**Parry Sound Canadian Coast Guard Base**  
**Building Envelope Remediation – Building A (Package 1)**  
**Building Envelope Remediation – Building B-G & K (Package 2)**  
28 Waubeek Street, Parry Sound, Ontario  
PWGSC Project No. R.064667.009

## **ADDENDUM NO. 1**

**June 1<sup>st</sup>, 2021**

drawing no.  
dessiné no.  
A-1000

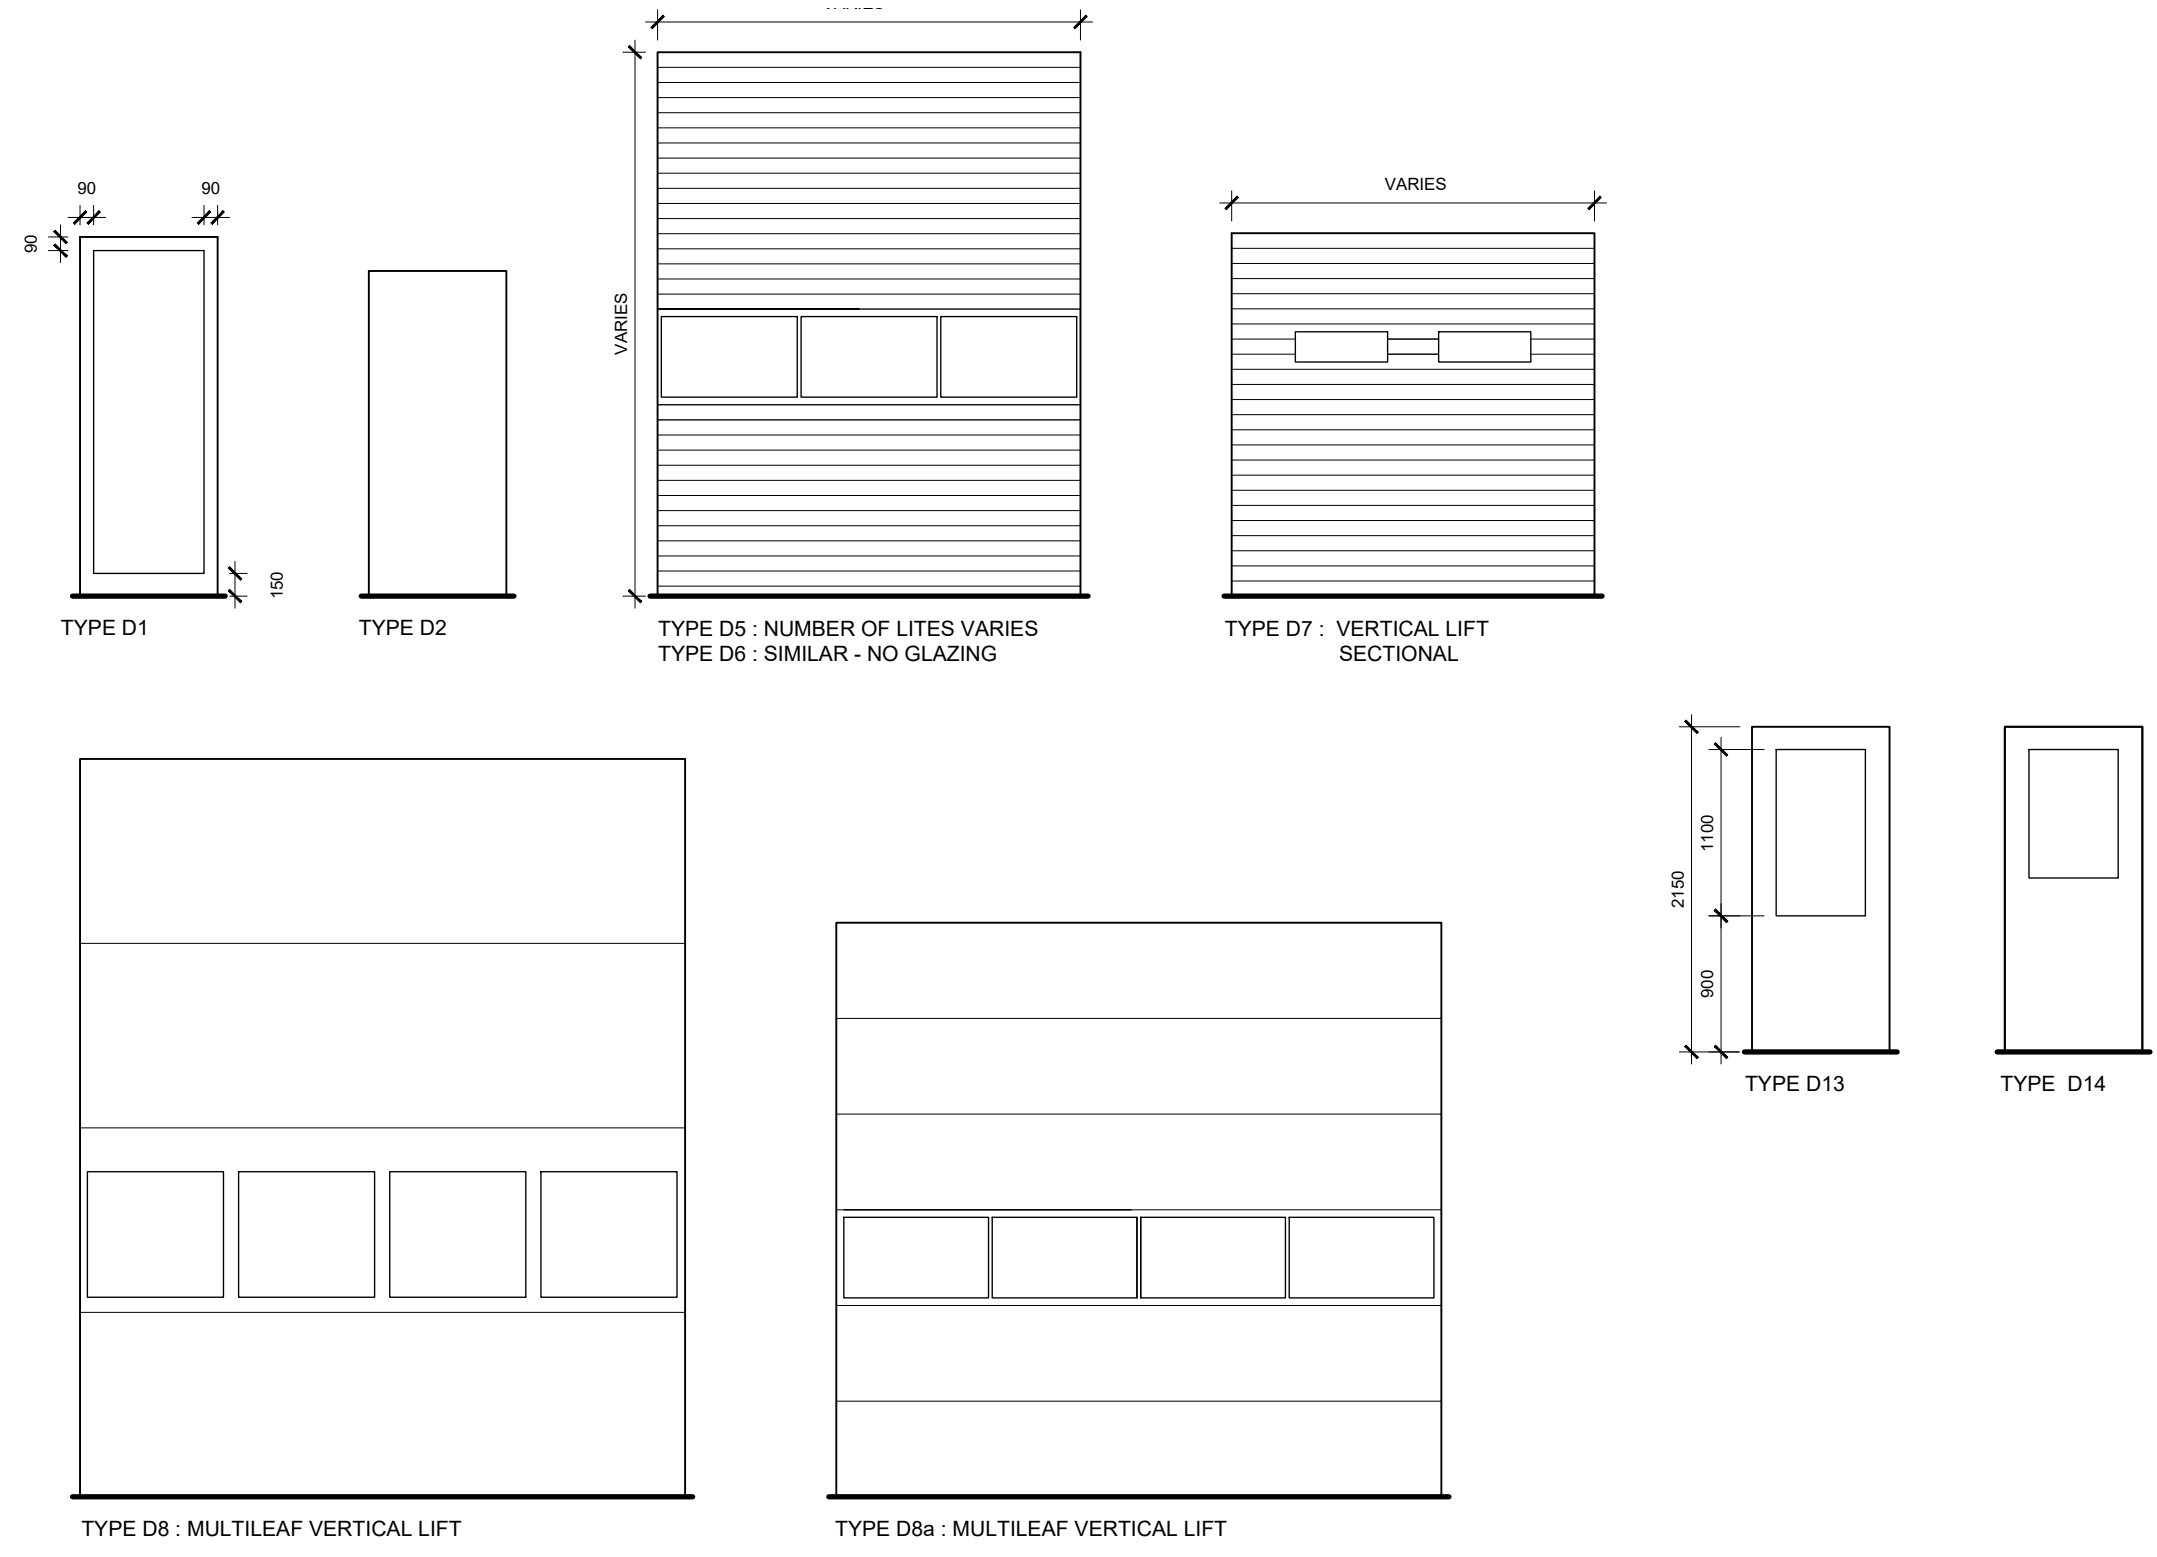
Package 1 and Package 2, Drawing A-1000 – Exterior Doors Schedule Updated to show Weather Stripping Replacement Scope and to remove Threshold Replacement Scope. Revised A1000 issued in Addendum 1.

Package 1, Drawings A-1000, Exterior Door Schedule Notes Updated to include scope of replacement of Glazing at D161C to match existing. Revised A1000 issued in Addendum 1.

Package 2, Drawings A-1000, Exterior Door Schedule Additional Notes Updated to

include scope of replacement of lockable exterior Door Handle for D195 to match existing. Revised A-1000 issued in Addendum 1.

- 1 - Glazing replacement is not in scope for all doors except D161C. Glazing for D161C to be replaced to match existing.
- 2 - RESERVED
- 3 - RESERVED
- 4 - RESERVED
- 5 - RESERVED
- 6 - Confirm dimensions on site
- 7 - RESERVED
- 8 - RESERVED
- 9 - RESERVED
- 10 - RESERVED
- 11 - Remove applied paint on metal bollards and freestanding bumper guards, and repaint.
- 12 - Weather strips for man doors and overhead doors to be removed before surface prep and reinstated after painting. Interior weather strips do not need removal.
- 13 - Caulking scope includes replacement of all exterior caulking including around glazing.

Typical Notes			
11-	Remove applied paint on metal bollards and freestanding bumper guards, and repaint.		
12-	Weather strips for man doors and overhead doors to be removed before surface prep and reinstalled after painting; interior weather strips do not need removal.		
13-	Caulking scope includes replacement of all exterior caulking including around glazing.		
14-	Glazing replacement is not in scope.		
15-	All door dimensions to be confirmed on site.		
16-	Replace exterior lockable door handle for D195 to match existing.

drawn by dessiné par	NS/MP
designed by conçu par	GB, LN, CH
approved by approuvé par	CH
big titre	K.GOULD
project manager administrateur de projets	
project date date du projet	2021-06-01
project no. no. du projet	R.064667.009
drawing no. dessin no.	A-G01

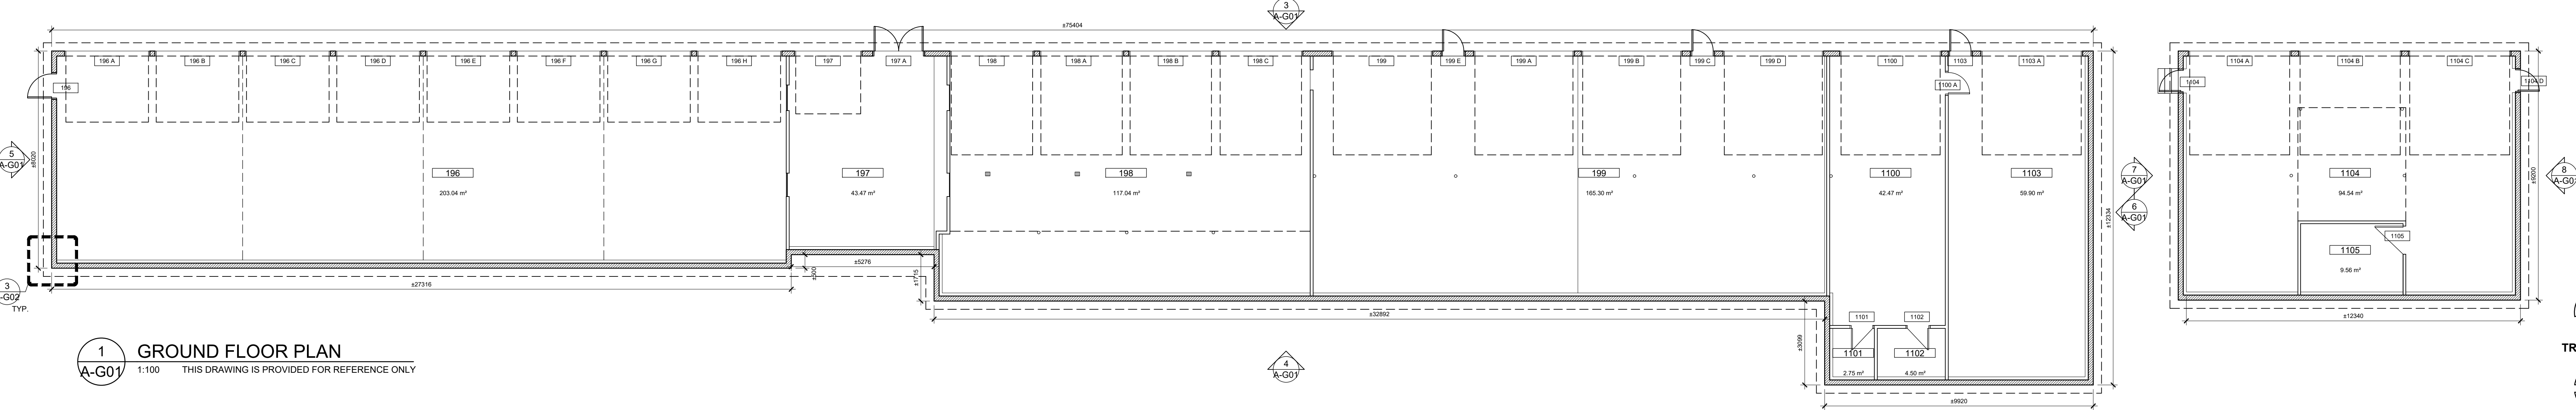
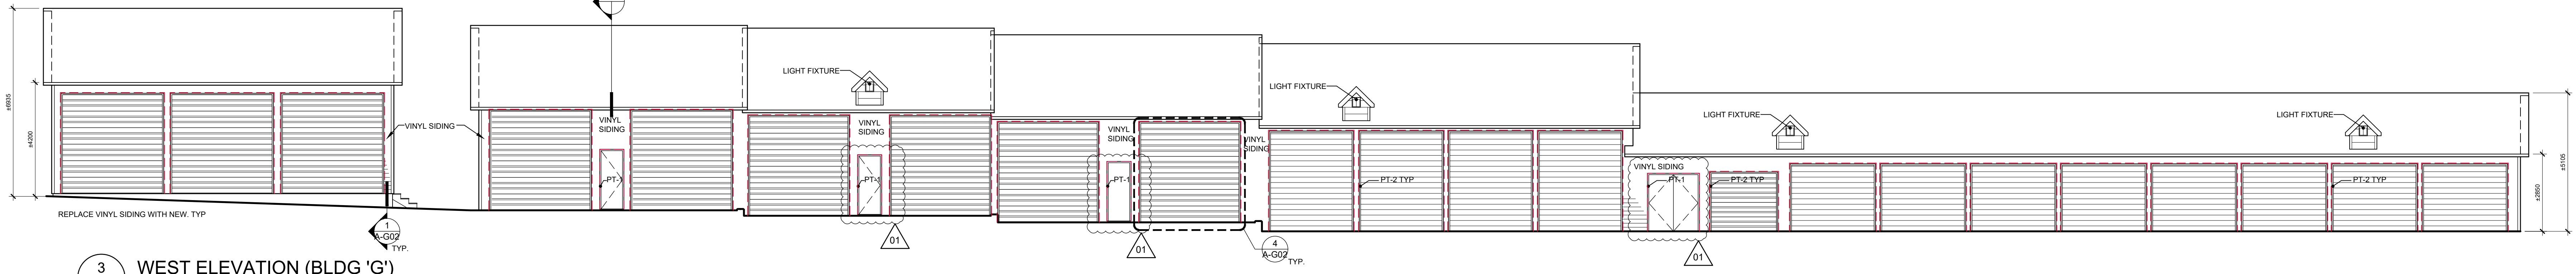
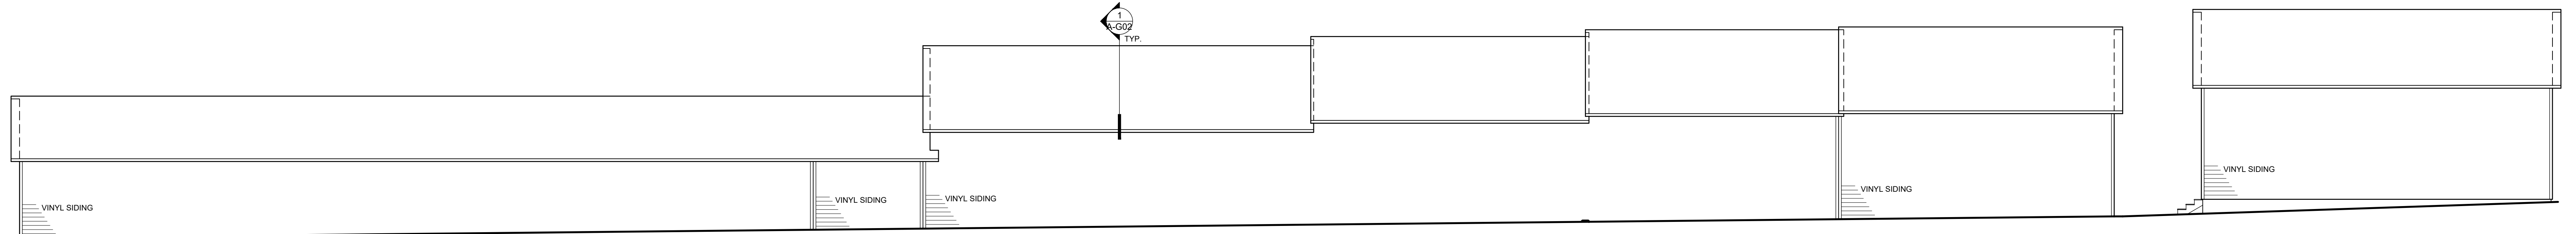
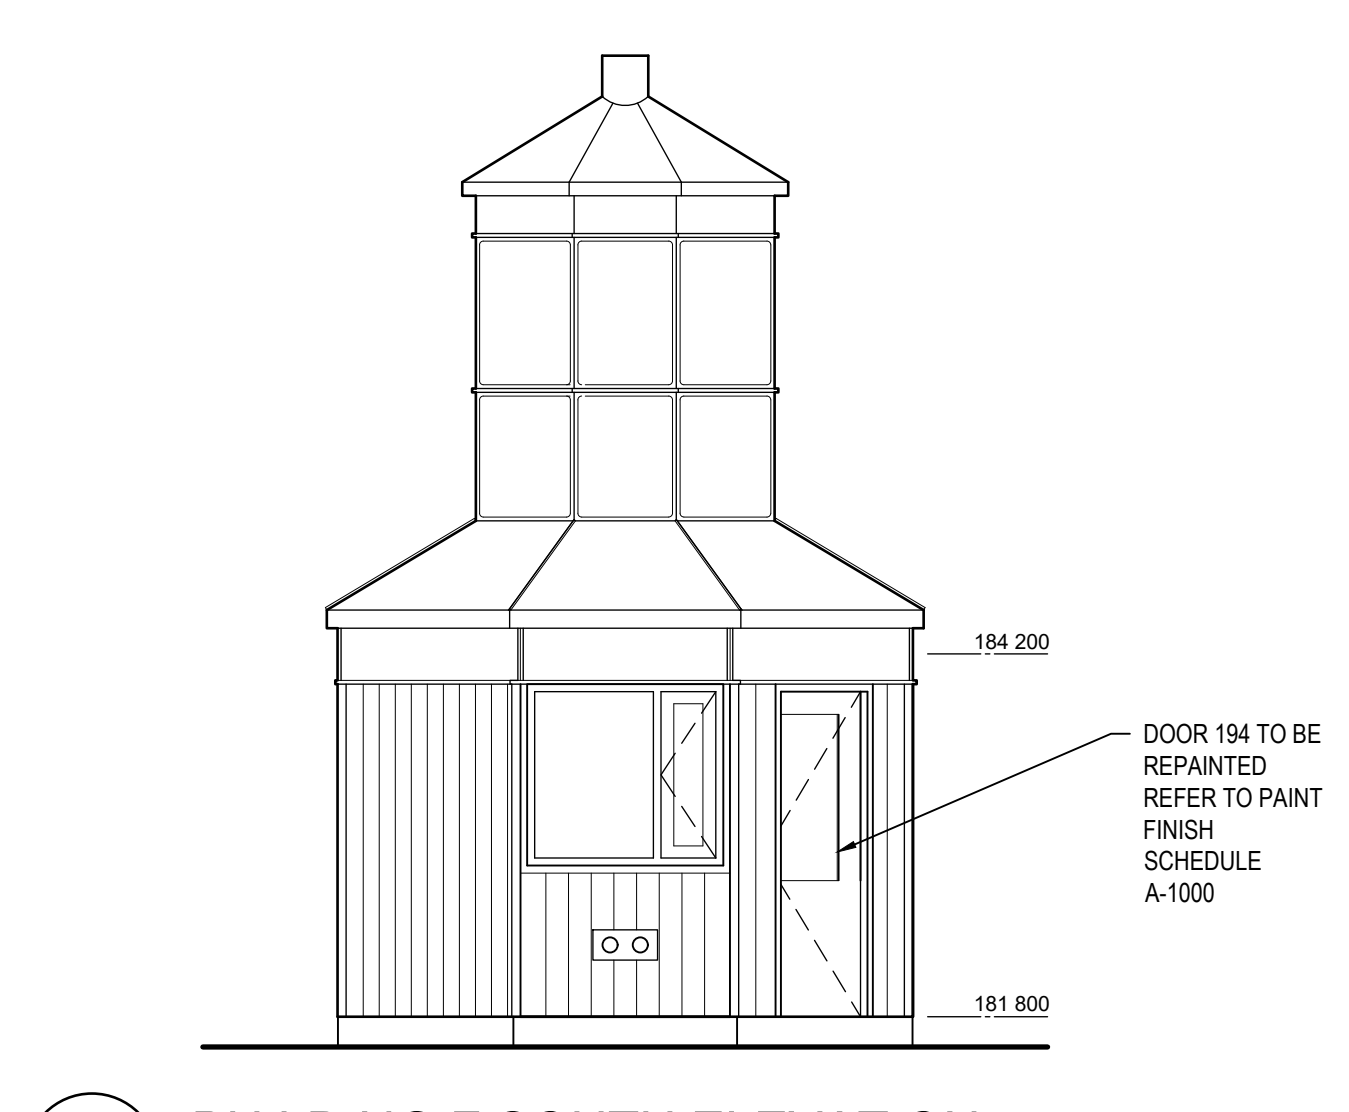
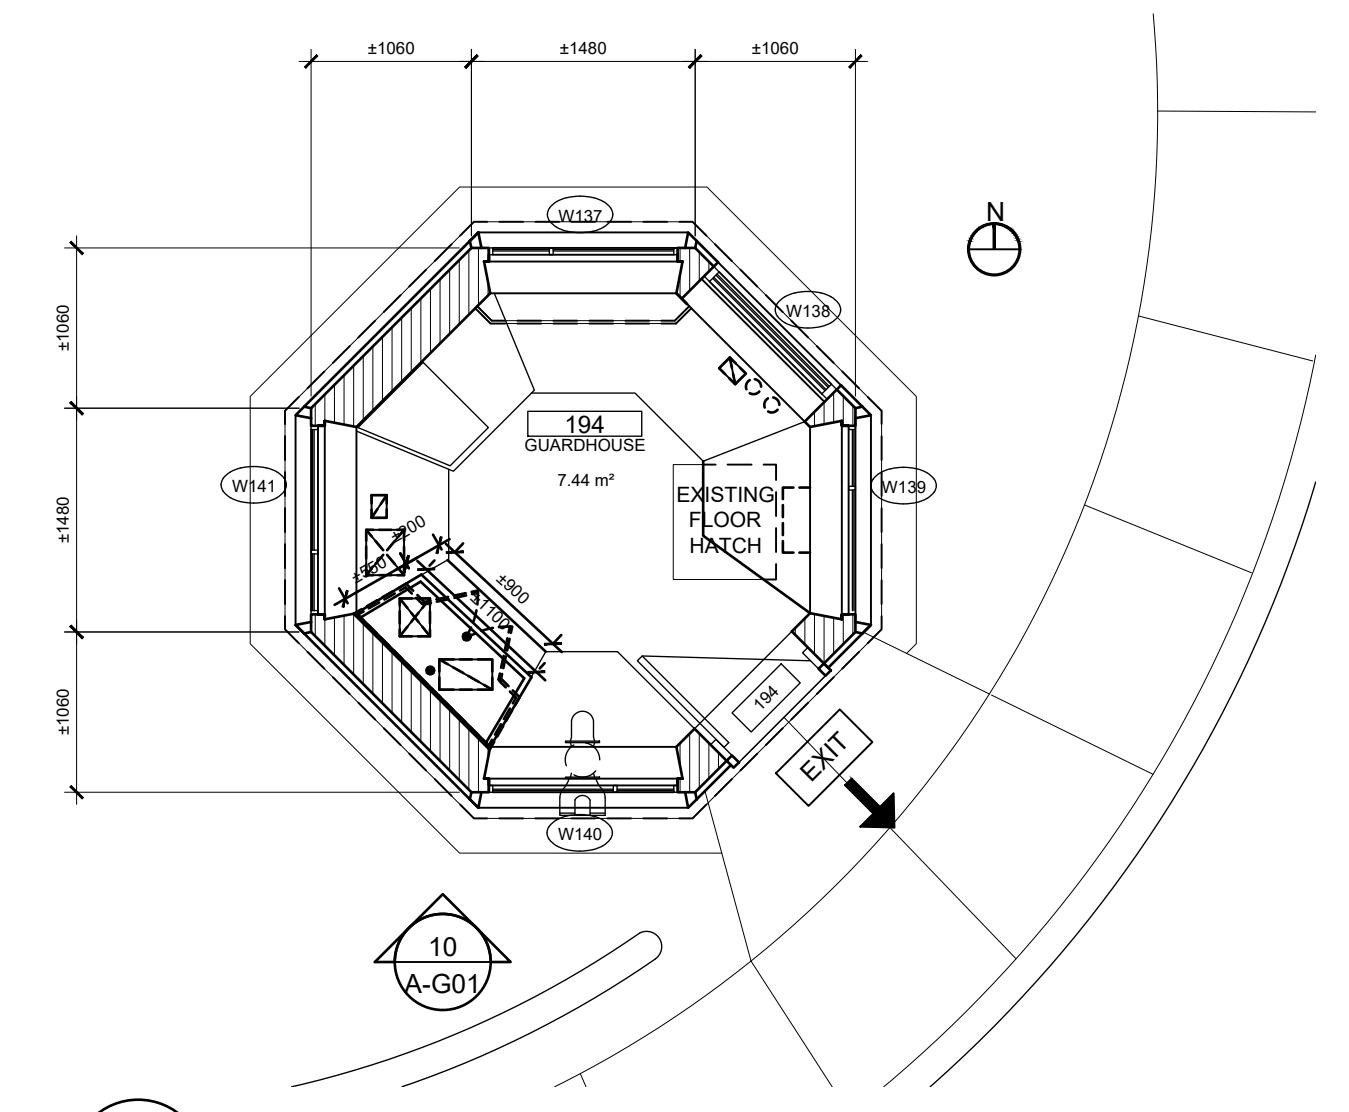
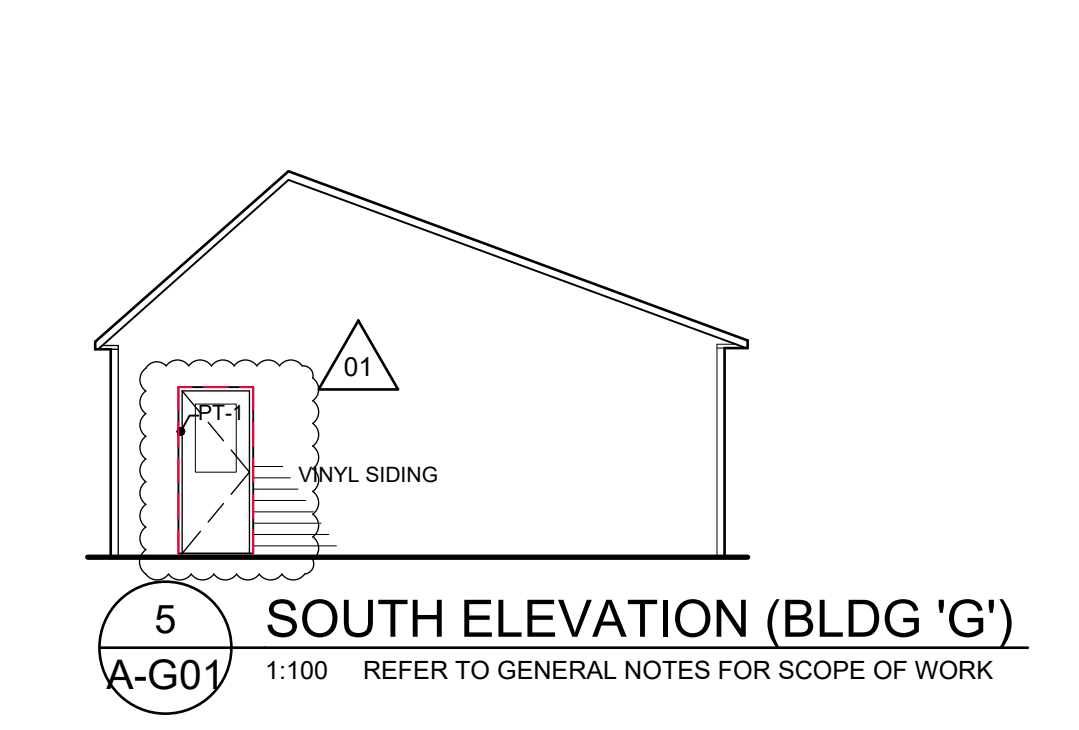
Package 2, Drawing A-G01, updated detail 3, 5, 7 & 8. Revised A-G01 Issued in Addendum 1.

- FOR WINDOW AND DOOR NUMBERS AND SCOPE REFER TO PLANS AND SCHEDULES.
  - REFER TO WINDOW AND DOOR SCHEDULE FOR WINDOW AND DOOR SCOPE OF WORK.
  - EXISTING EXTERIOR LIGHTING FIXTURES TO BE PROTECTED DURING COURSE OF WORK.

- MAKE GOOD FAULTY INSTALLATION OF VINYL SIDING (ALLOW FOR 10% TO BE RE-INSTALLED).
  - REPLACE ALL VINYL AND WOOD DOOR TRIMS WITH NEW. SEE DETAILS 7.8, 9/A-G02.
